11-AFC-1

**Re: Pio Pico Energy Center Project (11-AFC-01)
Correspondence to USEPA, Region 9**

Subject: Pio Pico Energy Center PSD Permit Application

Otay Mesa – Annual, 2004

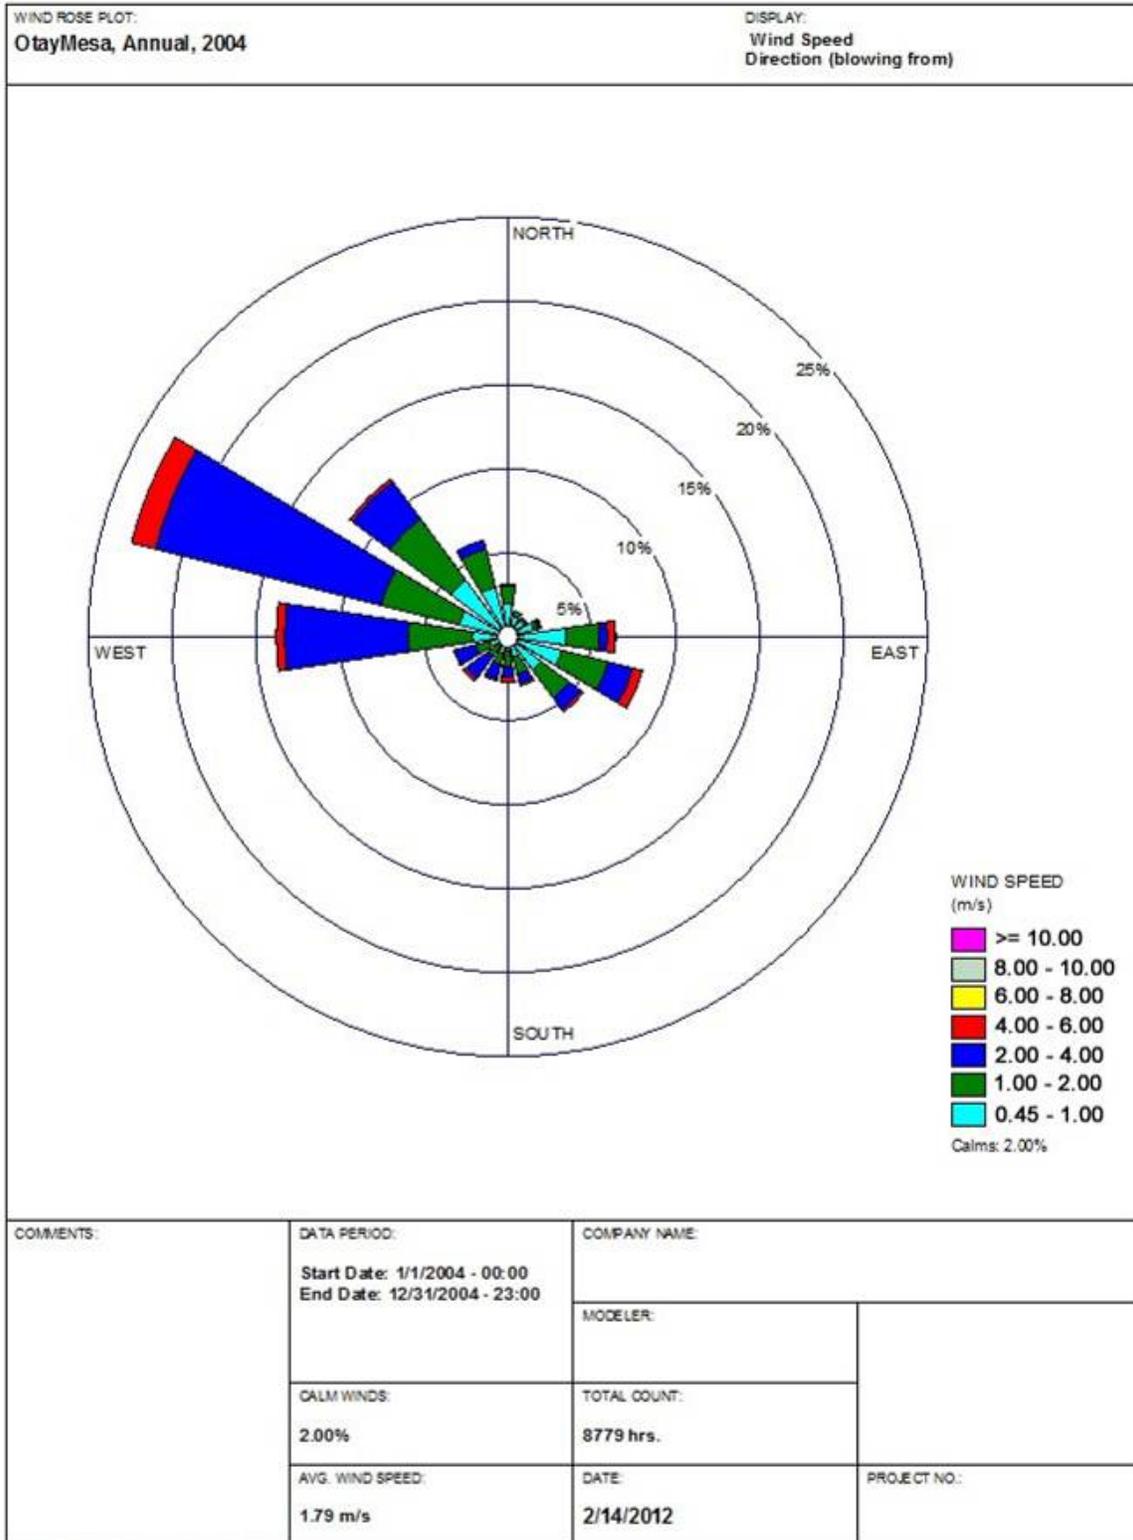
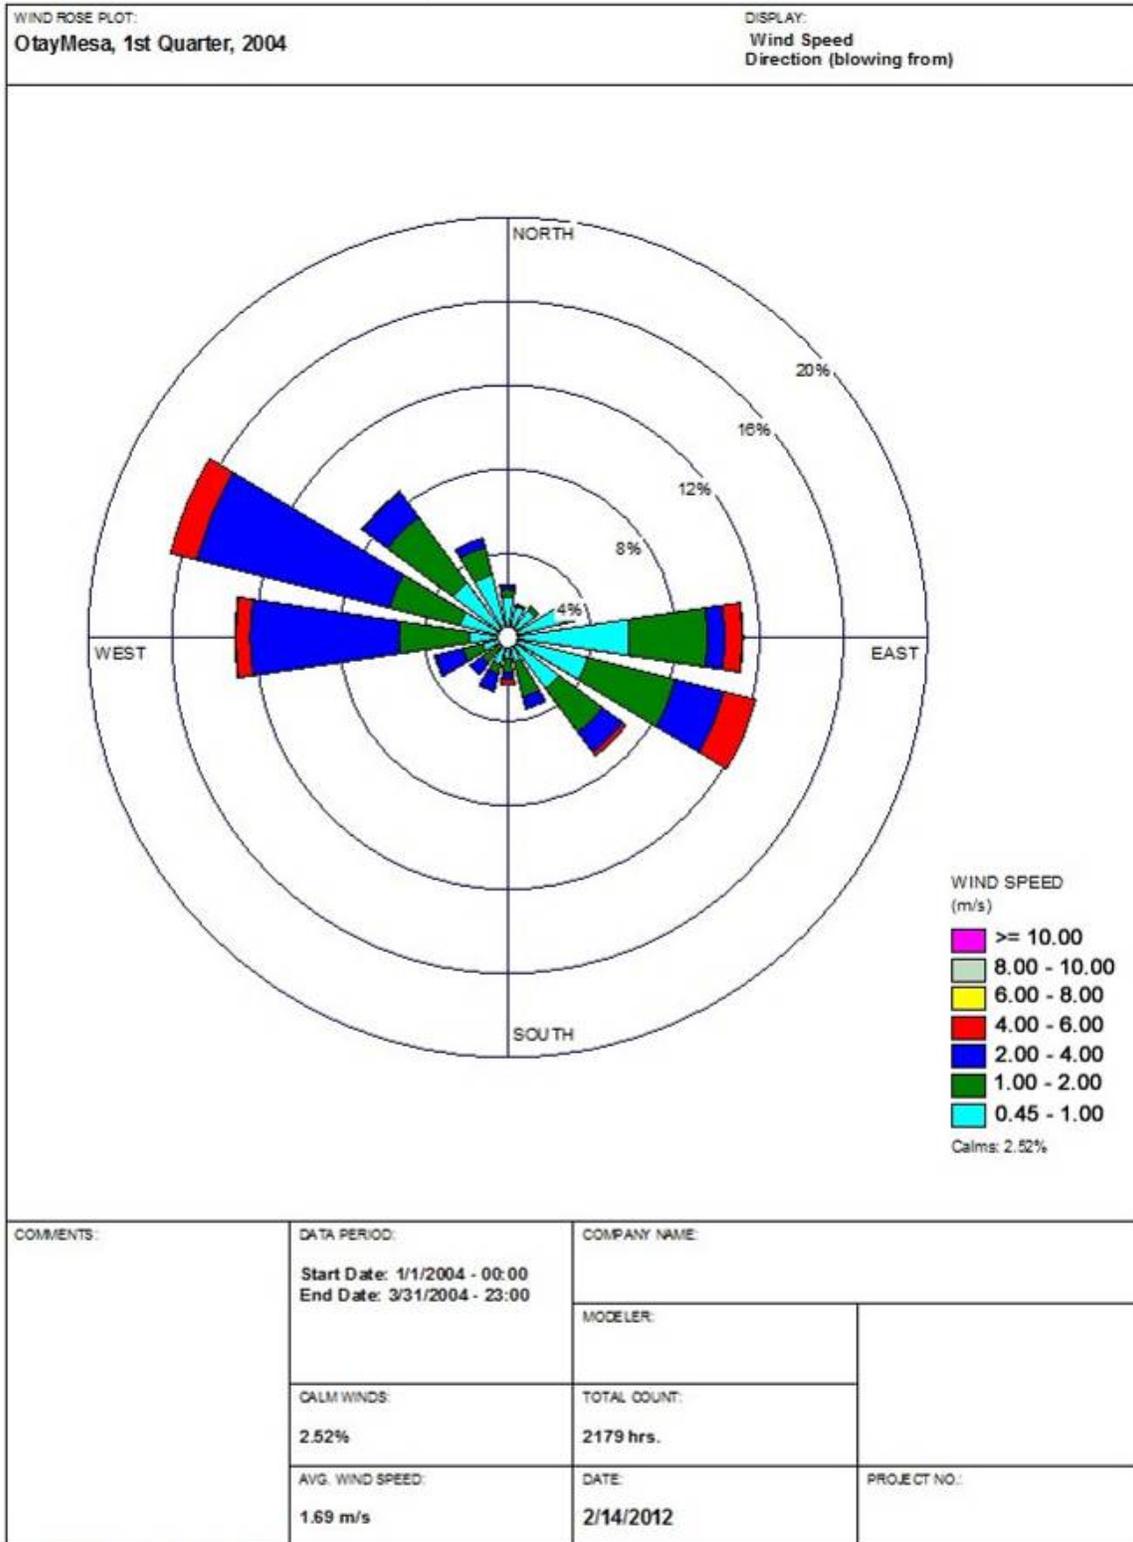
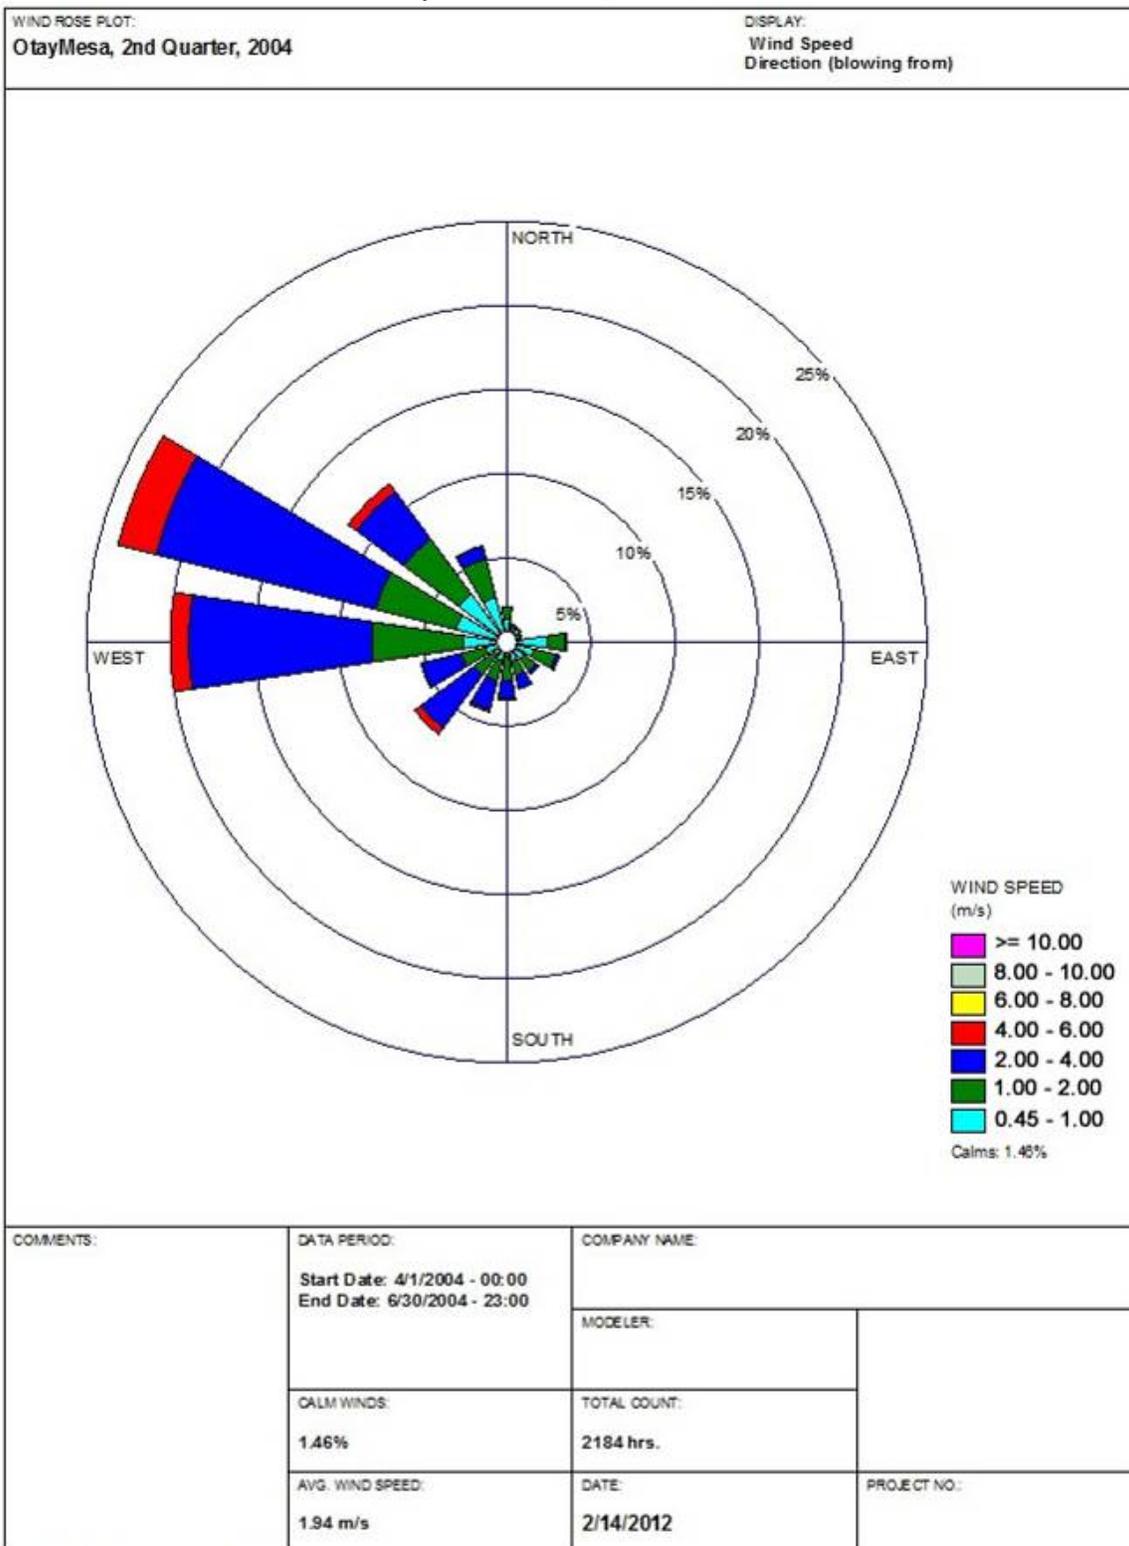
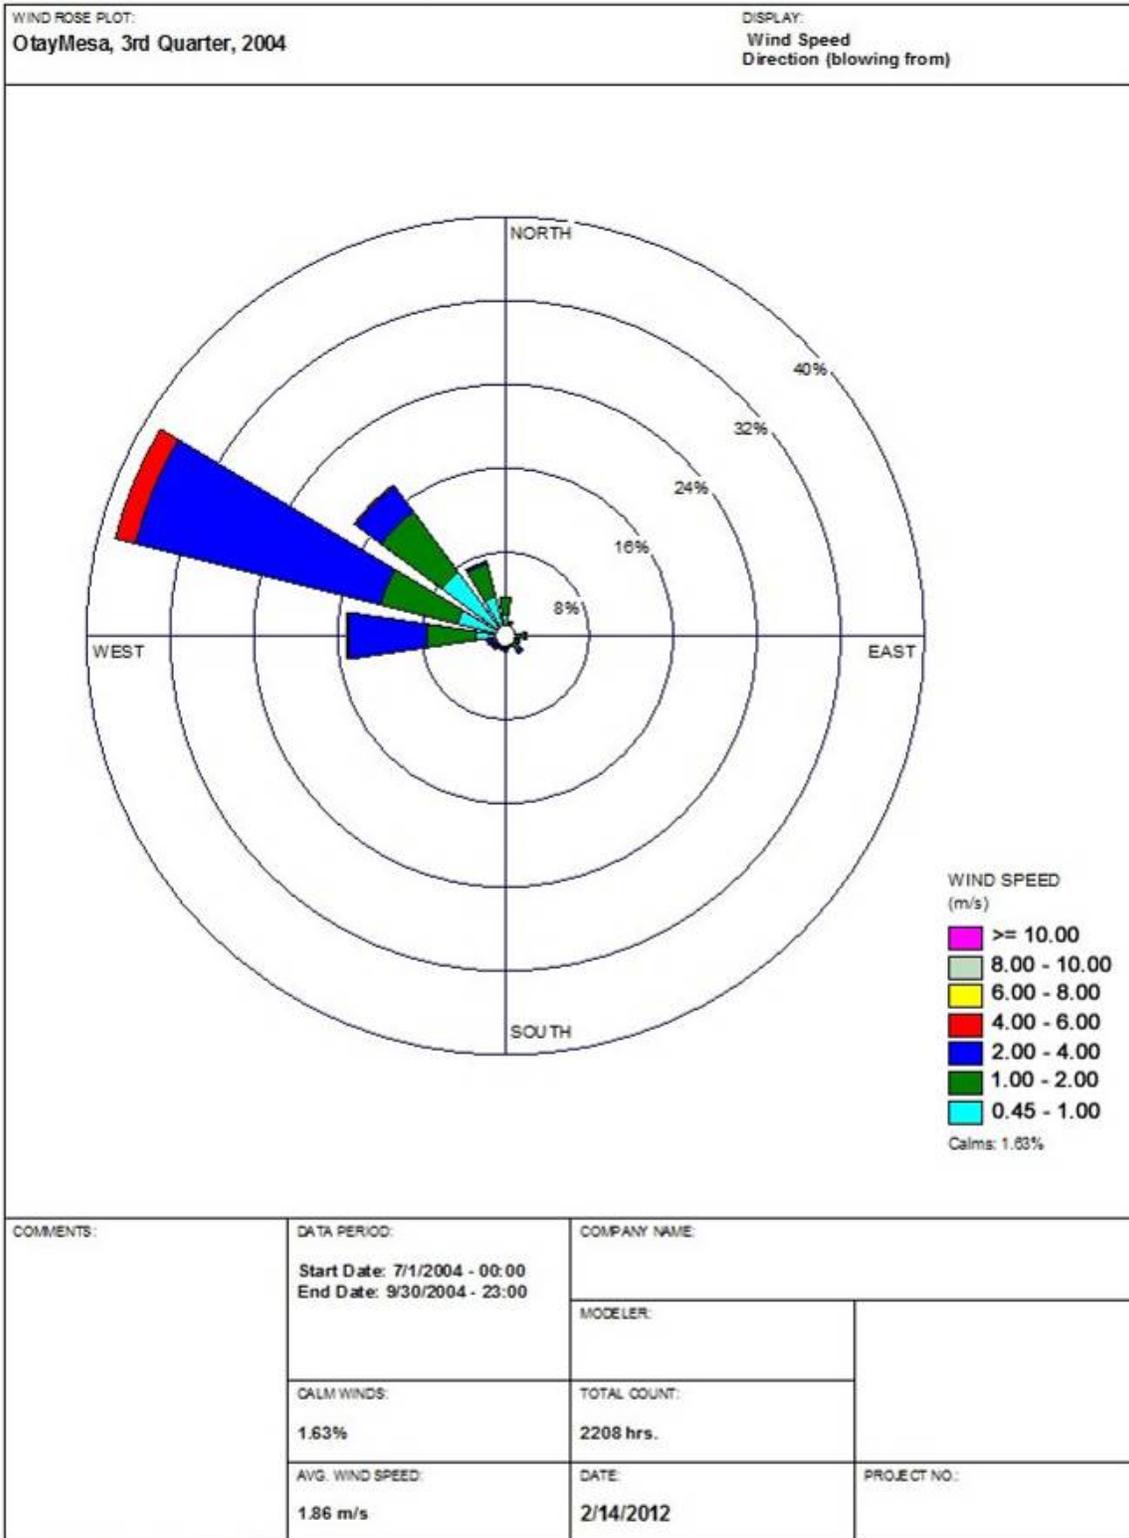
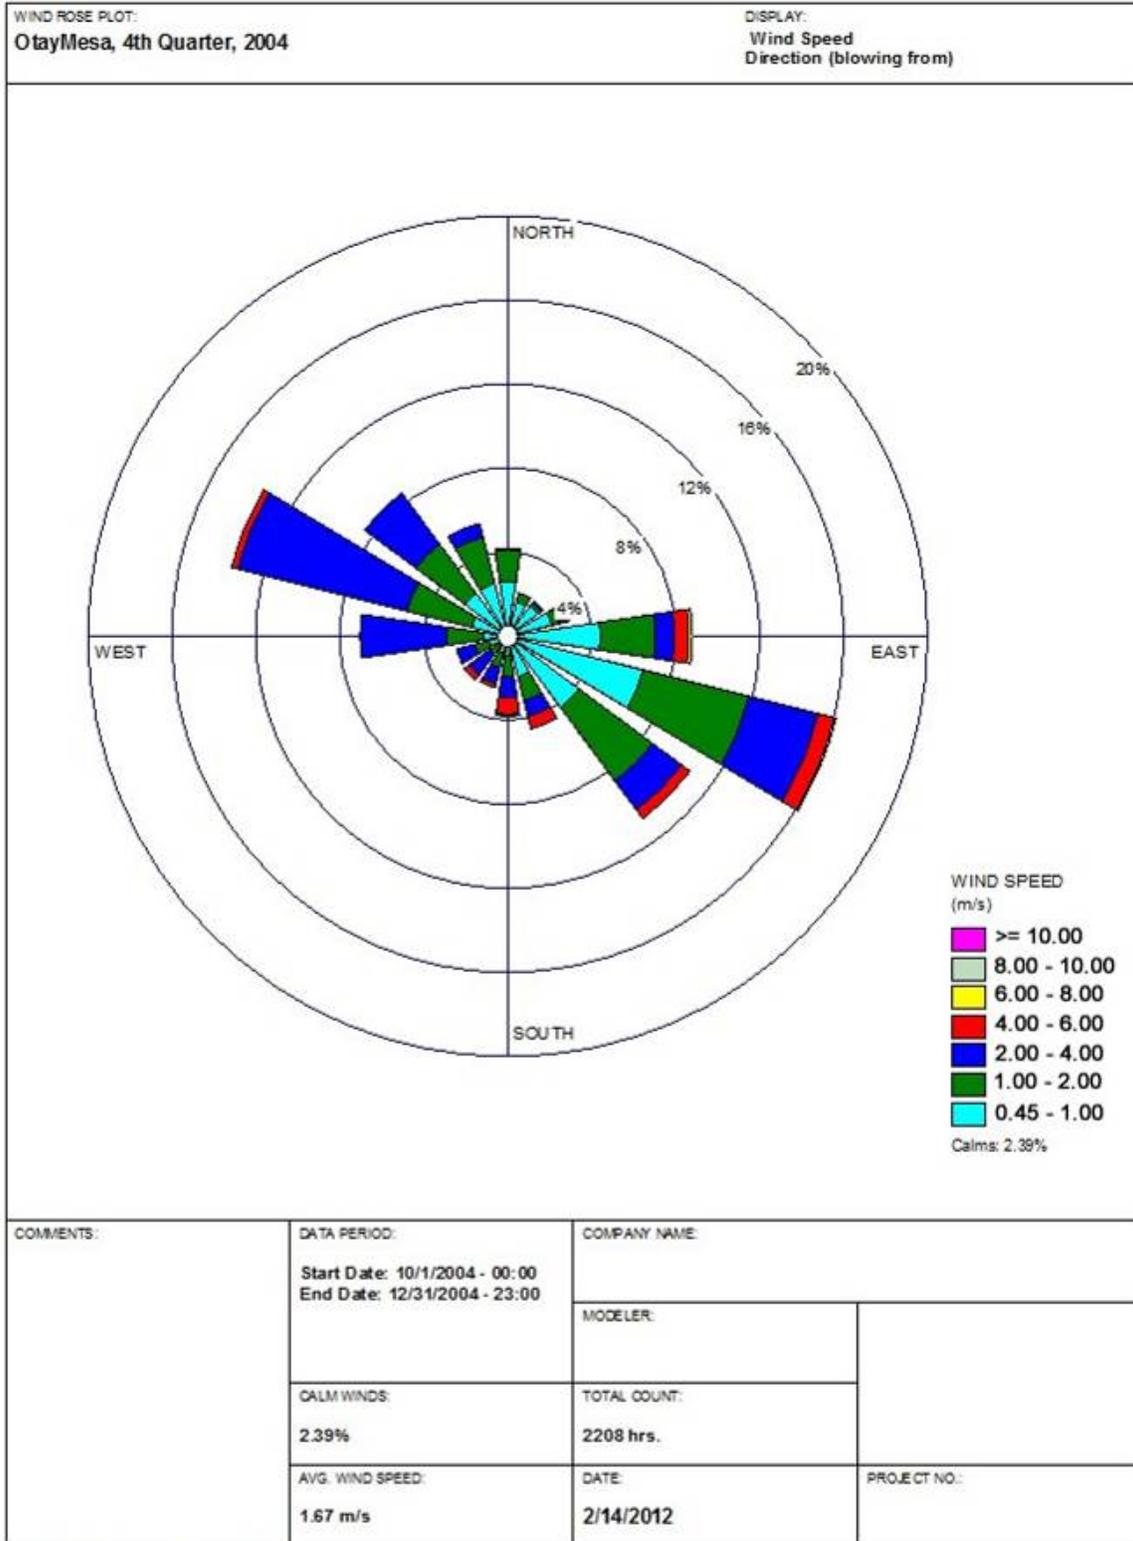
Comment: Please provide new wind rose graphics based on the definition of “calm” periods used in the modeling.

Response: In order to reduce the amount of time where wind speed is treated as “calm,” the San Diego Air Pollution Control District (SDAPCD or District) defines wind speeds below 0.45 m/sec as “calm” (standard definition is 0.5 m/sec). Charts were provided in the PSD application that graphically summarize quarterly and annual distributions of wind speed and direction (“wind roses”). The wind roses that were provided in the application used the standard cutoff for calm periods. EPA requested that Applicant provide wind roses that use the same cutoff used by the Applicant, following District guidance, in the modeling; the requested wind roses are attached.
